**Key objections to the ‘soundness’ of  
AMENDMENTS to  
SLDC’s *Land Allocation Development Plan  
Document (LADPD)*  
for Grange-over-Sands and district**

**May 2013**

This statement has been prepared on behalf of Grange-over-Sands & District Action Group (GADAG), representing more than 200 members and supporters who are residents of Grange-over-Sands and of the Cartmel Peninsula, Cumbria.

**DO NOT protect against COALESCENCE**

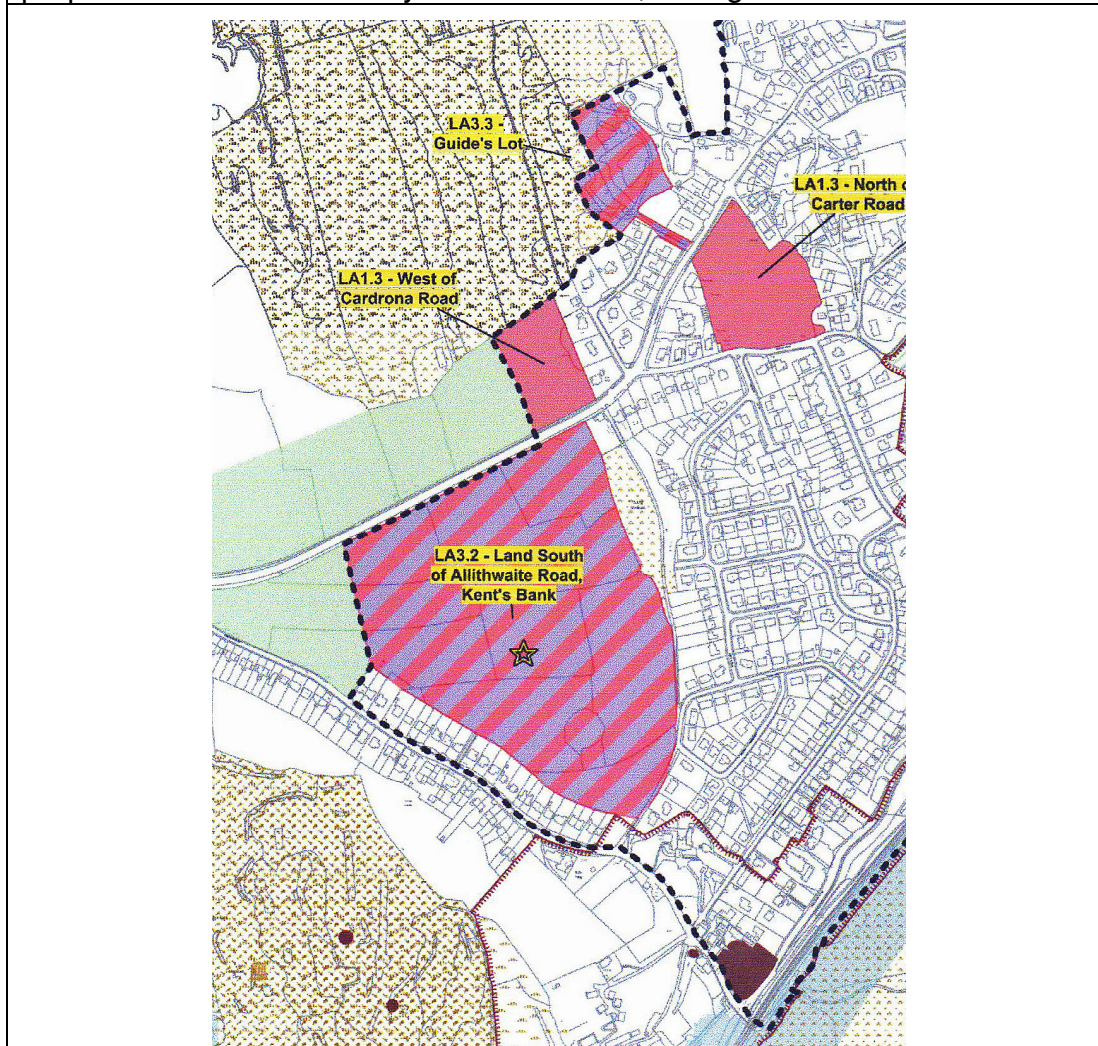
- **SLDC's green gap assessment:** is incompetent, contains factual inaccuracies, does not define the extent of the current green gap or the proposed green gap and suggests that a 220 metre gap on the B5277 through road (Allithwaite Road) is sufficient to protect against coalescence.
- **Southern side of the B5277:** The Impact of development proposal *LA1.3 Land south of Allithwaite Road* HAS NOT BEEN INCLUDED in SLDC's GREEN GAP ASSESSMENT even though it will cover 11.2 hectares of green fields that separate Kents Bank, Grange-over-Sands from Allithwaite.
- **Proposed green gap:** a 220 metre gap on the B5277 through road (Allithwaite Road) is sufficient to protect against coalescence.

Even though **Grange-over-Sands Town Council** and **local residents** have alerted SLDC to this problem throughout SLDC's *Public Consultation* exercises in **2010**, **2011** and **2012** and at the **Public Hearing in October 2012** **SLDC has NOT AMENDED** their **LADPD** to address the **SIGNIFICANT IMPACT** that their **PROPOSED GREEN GAP** will create for the **INTEGRITY** of **KENTS BANK** and **ALLITHWAITE** as **SEPARATE COMMUNITIES**.

**Map 3** Section from SLDC's Map EX063 Grange South showing SLDC's proposed eastern boundary for Allithwaite (from map modified by SLDC May 2013)

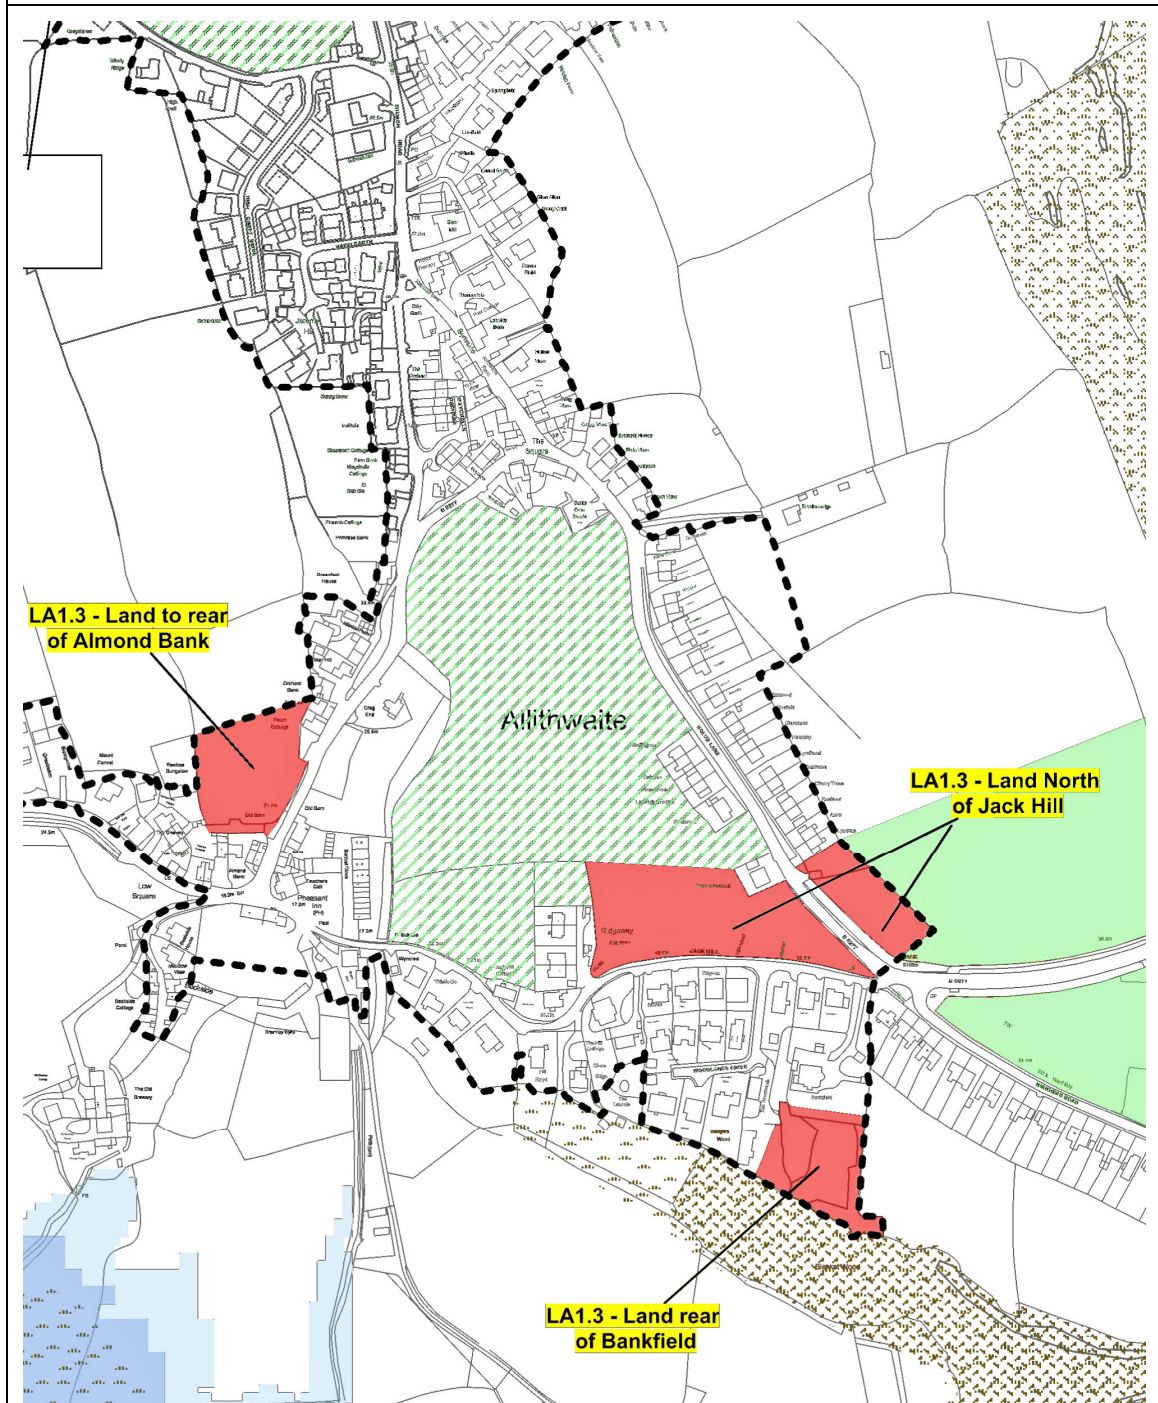
**Note**

1. The south eastern boundary of Allithwaite is shown as crossing the B5277 at the top of the junction with Jack Hill and Kirkhead Road.
2. However, on Ordnance Survey maps all the houses above Laneside Farm, on Kirkhead Road, are shown as being within the Allithwaite boundary.
3. SLDC's map places the houses at the top of Kirkhead Road in no-man's land.
4. The proposed Kents Bank boundary for site LA3.2 Land South of Allithwaite Road (MN25M), is just 220 metres along the B5277 to the east and is not shown on this map.

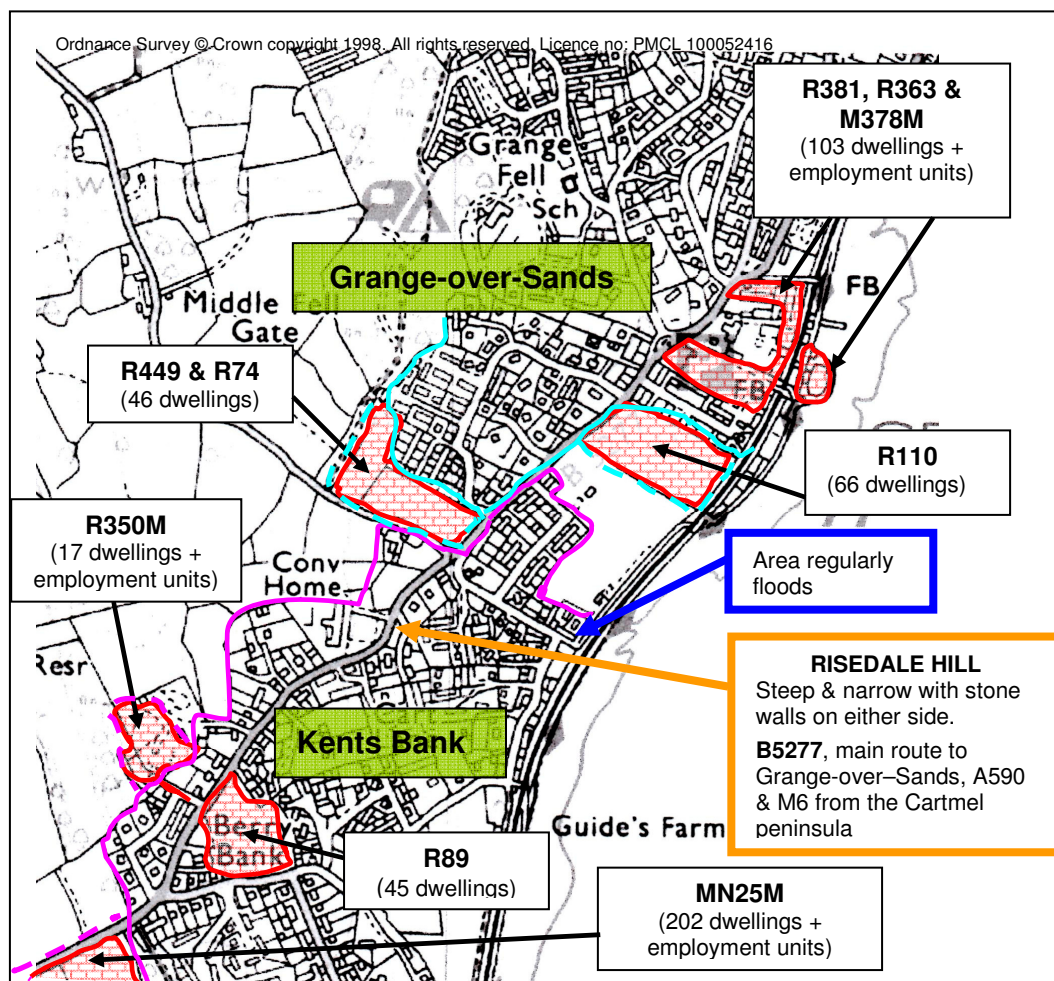
- **Proposed development in Conservation Area 3:** will destroy one of the remaining green field sites that are an integral part of the Victorian heritage of the town. This area of was left open so that visitors to the town could enjoy the ever-changing views of Morecambe Bay.
- **Proposed development opposite Conservation Area 3:** will destroy a green field site that is an integral part of mosaic of green field pastures that typify the vernacular architecture and setting of Grange-over-Sands.

Even though **Grange-over-Sands Town Council** and **local residents** have alerted SLDC to this problem throughout SLDC's *Public Consultation* exercises in **2011** and **2012** and at the Public Hearing in October 2012 **SLDC HAS NOT AMENDED** their **LADPD** to address the **SIGNIFICANT IMPACT** that their **PROPOSED INFILLING DEVELOPMENT ALLOCATIONS** will have **Grange-over-Sands'** unique identity as a Victorian coastal resort.
